SUBJECT: Response to Near-Term Bedrock Groundwater Evaluation Work Plan
JCI/Tyco Stanton (PFAS), 1 Stanton Street, Marinette, WI
*JCI/Tyco FTC PFAS, 2700 Industrial Parkway South, Marinette, WI**
BRRTS #02-38-581955 and #02-38-580694*
** DNR added this BRRTS case into the tracking of the work plan*

On May 11, 2020 the Wisconsin Department of Natural Resources (DNR) received the *Near-Term Bedrock Groundwater Evaluation Work Plan* ("Bedrock SI Work Plan"), dated May 1, 2020, and submitted by Arcadis U.S., Inc. (Arcadis), on behalf of Johnson Controls, Inc. and Tyco Fire Products LP (JCI/Tyco). The report was accompanied by the appropriate fee of \$700, required under Wisconsin Administrative Code (Wis. Adm. Code) § NR 749.04(1), for formal DNR review and response.

Attachment A: Referenced Figures

TYCO FIRE PRODUCTS LP MARINETTE, WISCONSIN	
Cross Section A-A' PFOA+PFOS Plume Contours of Recent Sampling Results	
ARCADIS	FIGURE 1

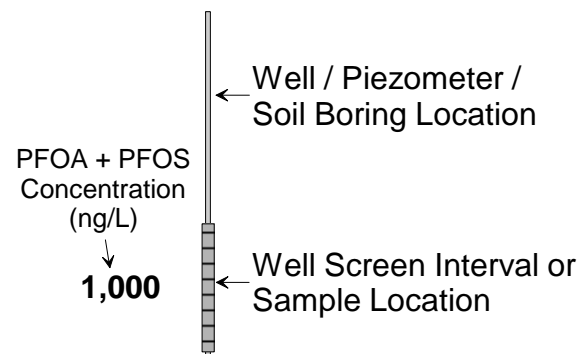
- The bedrock is approximately 35 to 50 feet below ground surface (ft bgs).
- In many locations throughout the area, including on the Stanton property, the bedrock is separated from the unconsolidated aquifer by a low-permeability glacial till (Arcadis' Figures 1, 6 and 7 **Attachment A**). Where present, the glacial till limits the downward migration of groundwater from the upper unconsolidated units into the bedrock.

- In some locations, south and west of the Stanton Site, the low-permeability till is absent; medium to coarse sand and gravel is in contact with the bedrock (Arcadis' Figures 1, 6 and 7 in **Attachment A**). The absence of the low-permeability glacial till allows for a hydraulic connection between the unconsolidated aquifer and the bedrock at these locations.

FIGURE 1-4
 Conceptual Site Model Post-barrier Wall
 Tyco Fire Products LP
 Marinette, Wisconsin

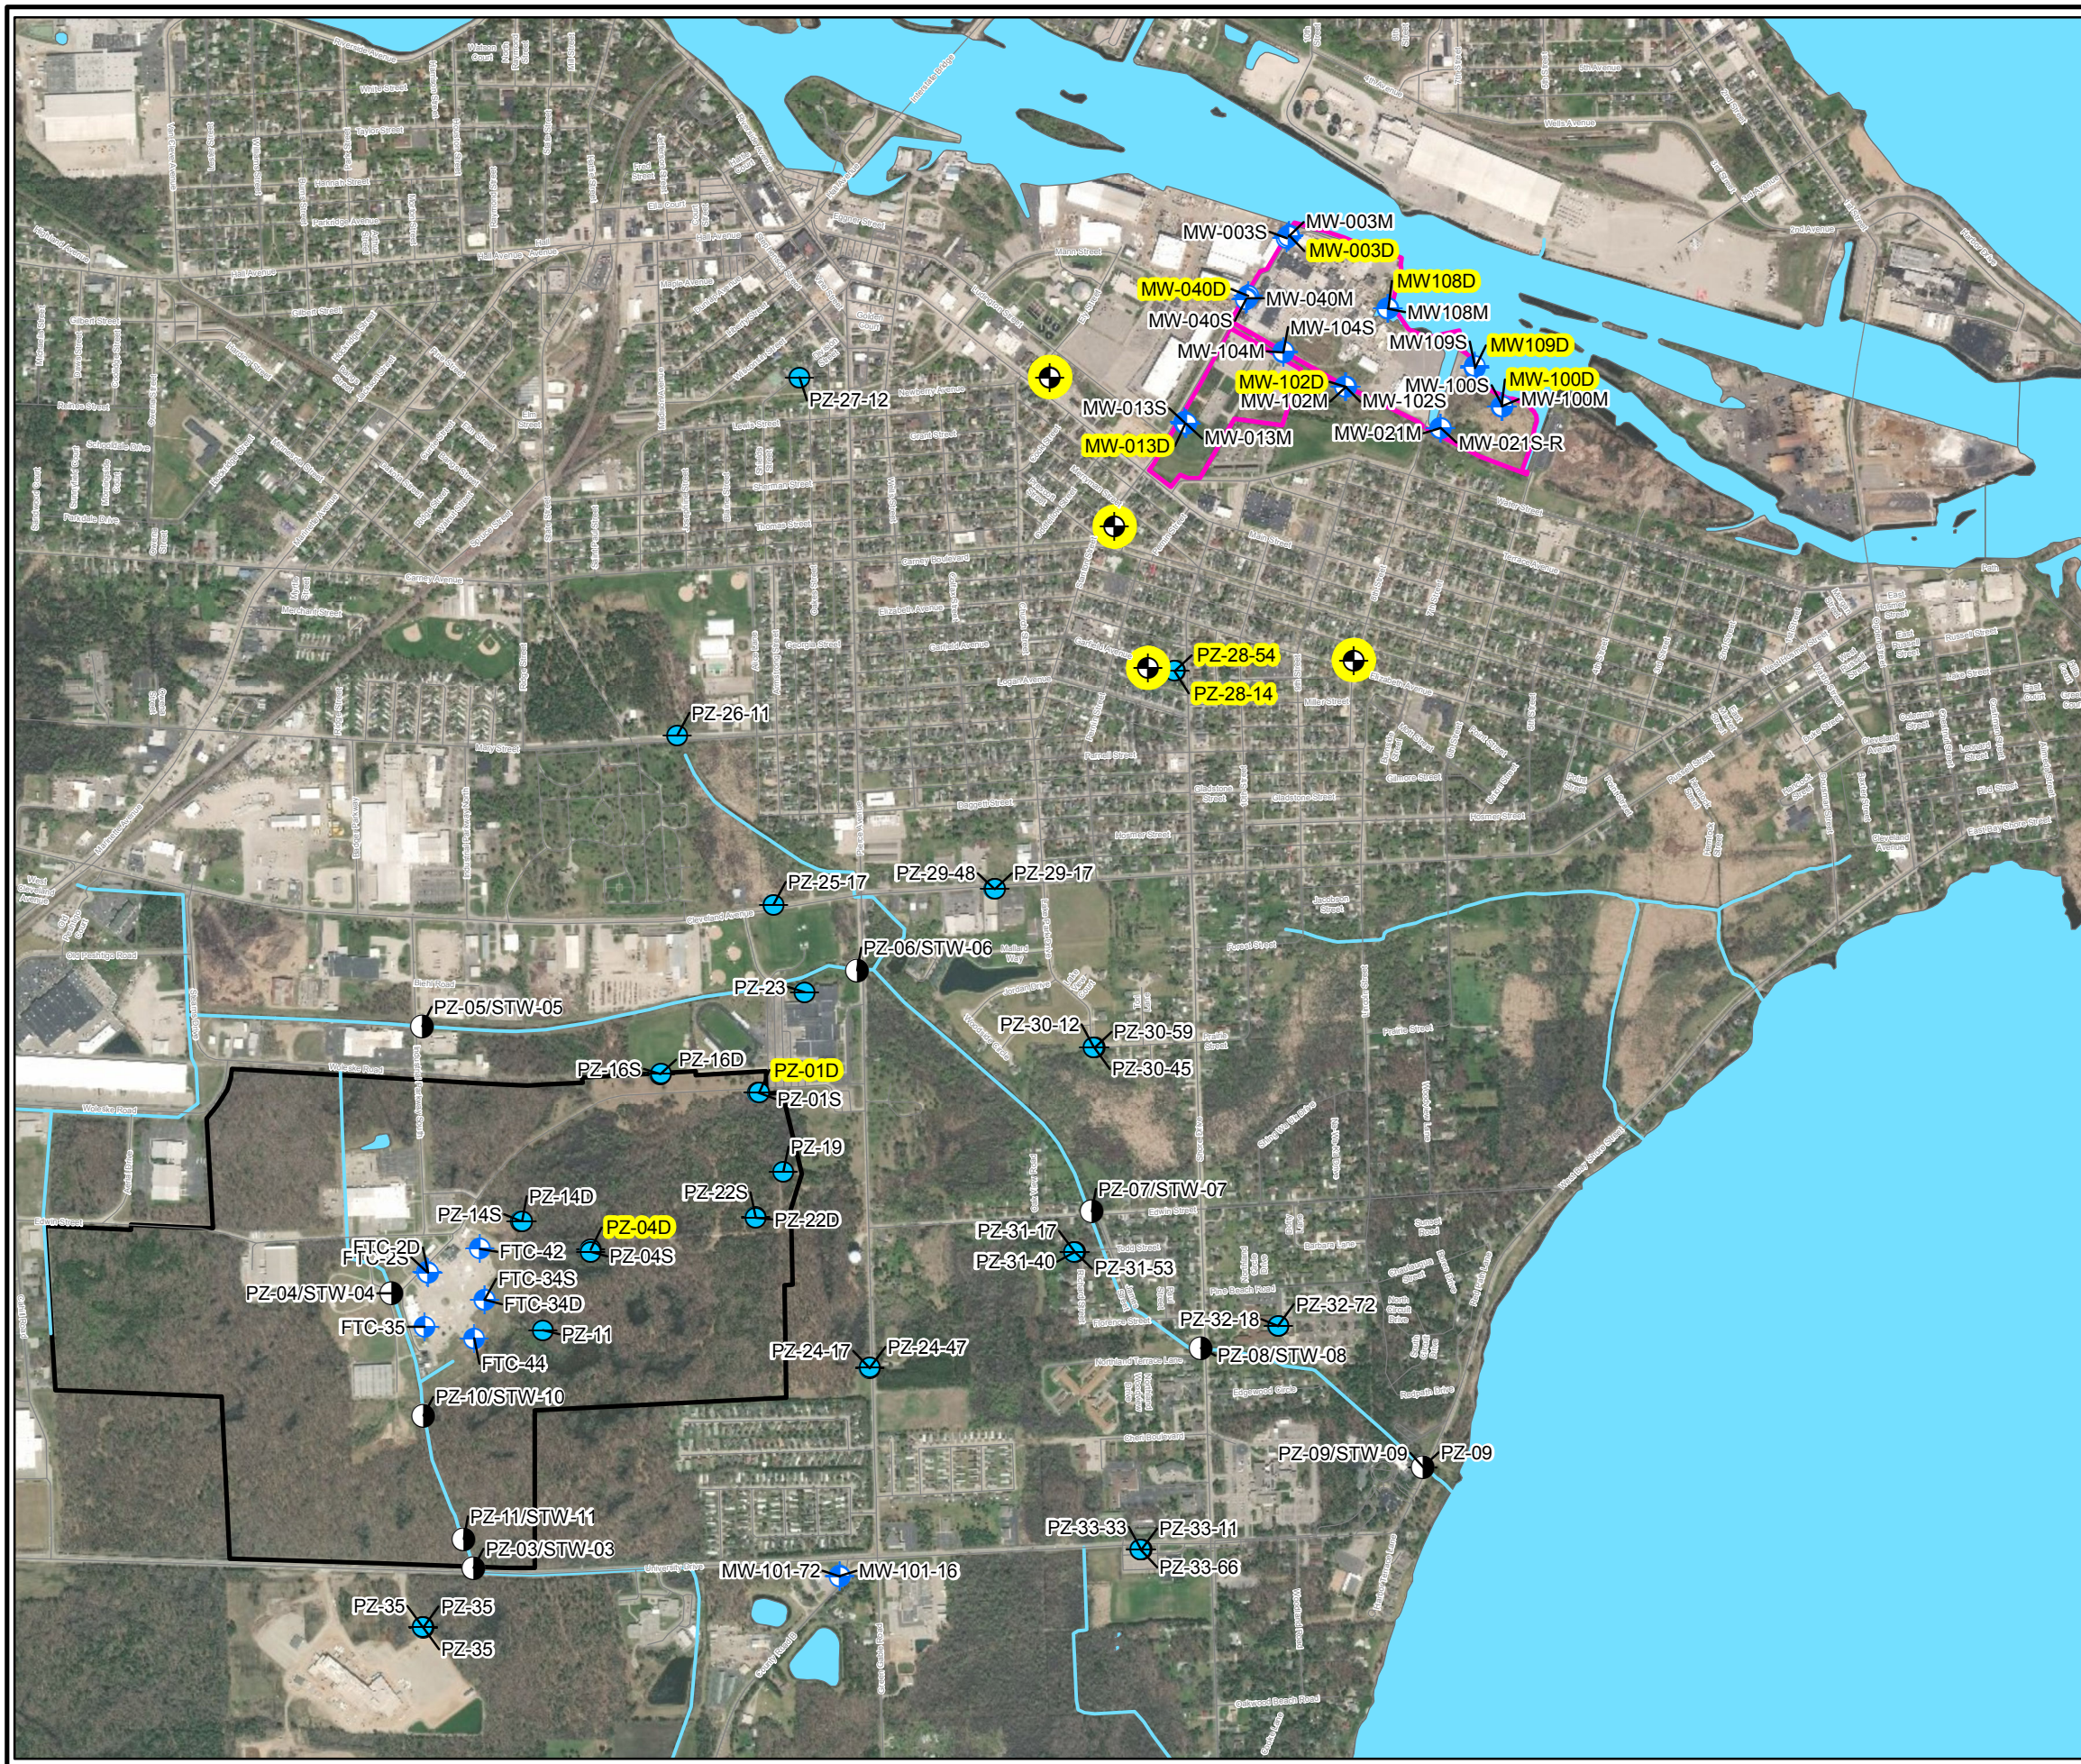
- One of the corrective action measures in place for the arsenic contamination is a groundwater barrier wall that encompasses the Stanton property and that is keyed into the low-permeability glacial till layer that sits on top of the dolomite bedrock (CH2MHill Figure 1-4 in **Attachment A**).

- Flow in bedrock groundwater appears to travel under the barrier wall to the Menominee River.
